1. The specifications and drawings for Invitation No. DACW64-03-B-0020, Dredging, Sabine Pass Channel, Port of Port Arthur, Sabine-Neches Canal Turning Basin in Jefferson County, Texas and Cameron Parish, Louisiana, Sabine-Neches Waterway, Texas, advertised 9 June 2003, and for which bids are rescheduled to be opened on 14 July 2003, are hereby modified as follows:

**SABINE-NECHES WATERWAY,
TEXAS, SABINE PASS CHANNEL, PORT OF
PORT ARTHUR, SABINE-NECHES CANAL
TURNING BASIN IN JEFFERSON COUNTY, TEXAS
AND CAMERON PARISH, LOUISIANA,
DREDGING**

(To Accompany Amendment No. 0003 to Invitation No. DACW64-03-B-0020)

TO BE ADDED TO SHT. 2 OF 36

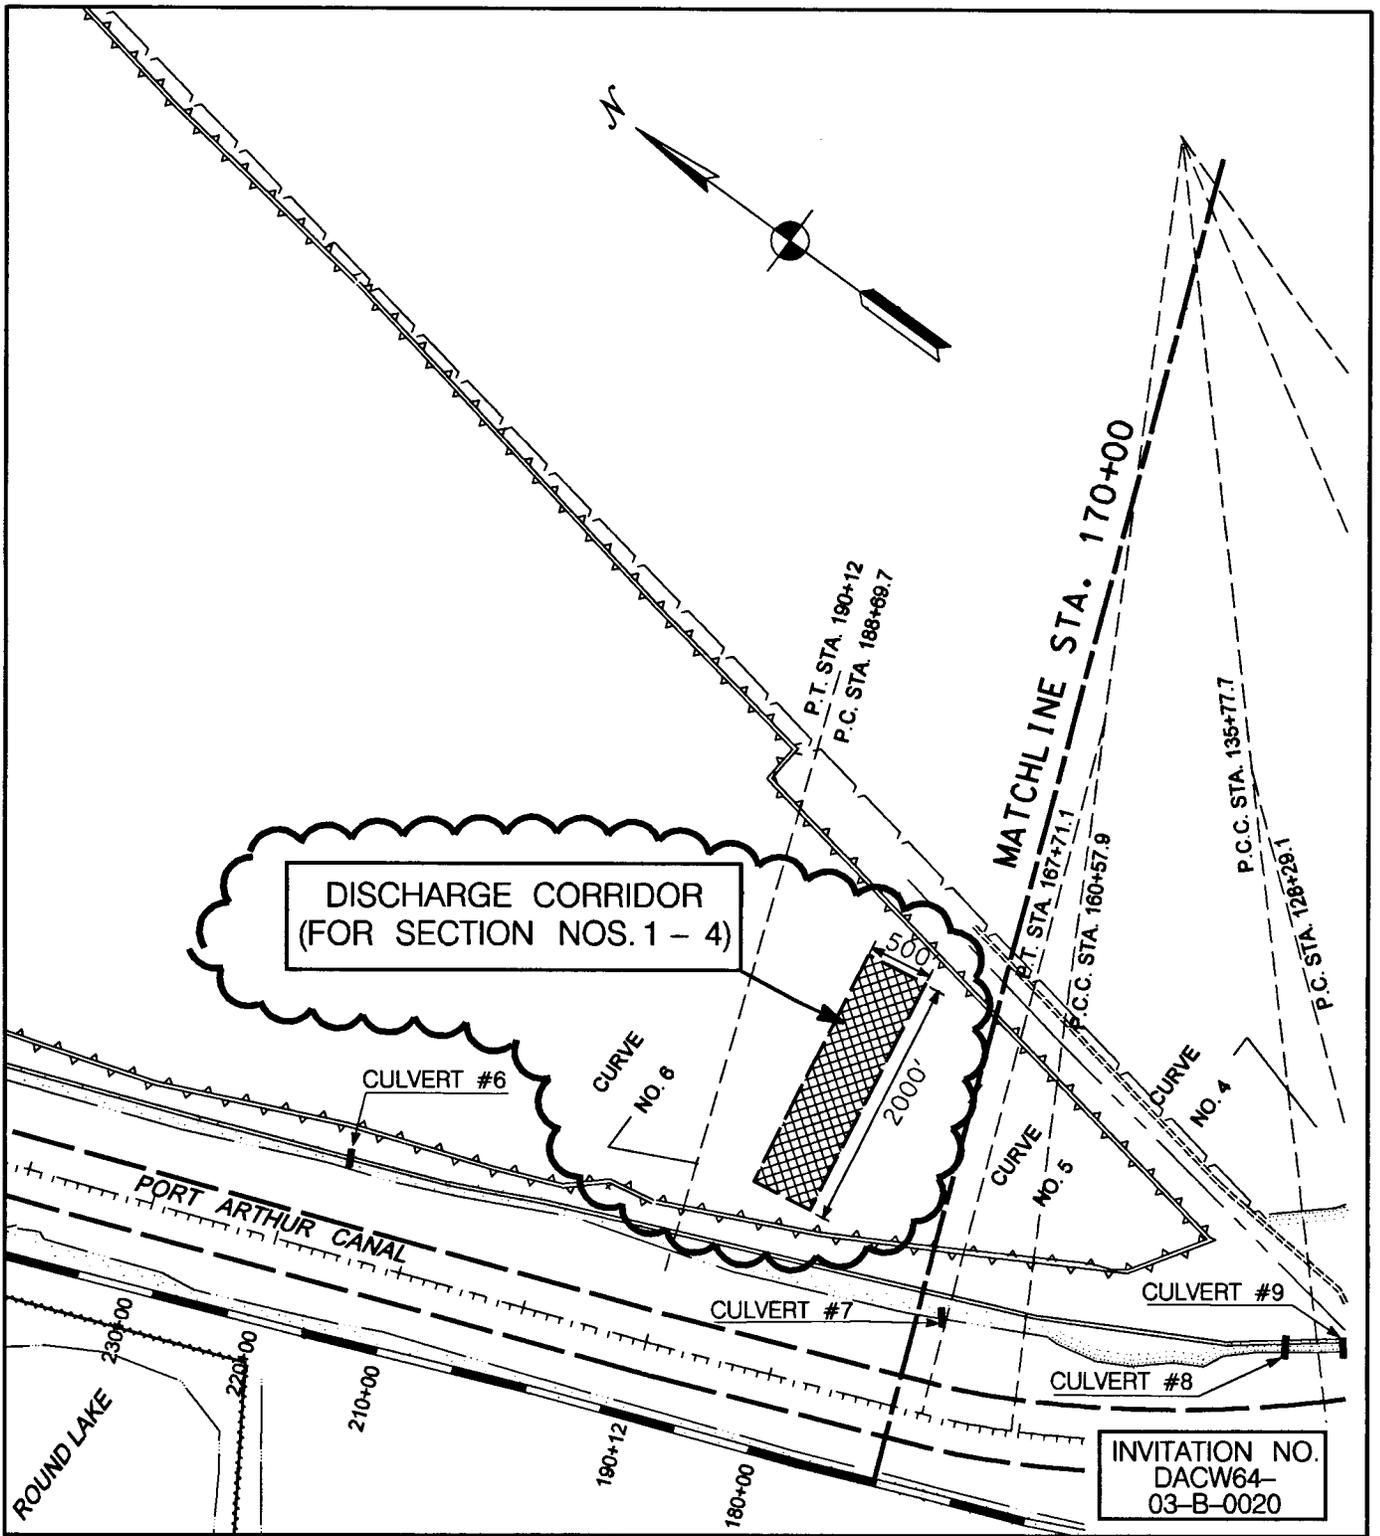
(1) Sheets Nos. 1 of 30 Through 3 of 30. - The new "Sheets Nos. 1 of 36 through 3 of 36" supersede "Sheets Nos. 1 of 30 through 3 of 30" and were issued with Amendment No. 0001 to this Invitation. Also, the enclosed SKETCH NO. 1 shall be added to Sheet No. 2 of 36 and shall become a part of this Invitation.

THIS SKETCH ACCOMPANIES
AMENDMENT NO. 0003 TO
INVITATION NO. DACW64-03-B-0020.
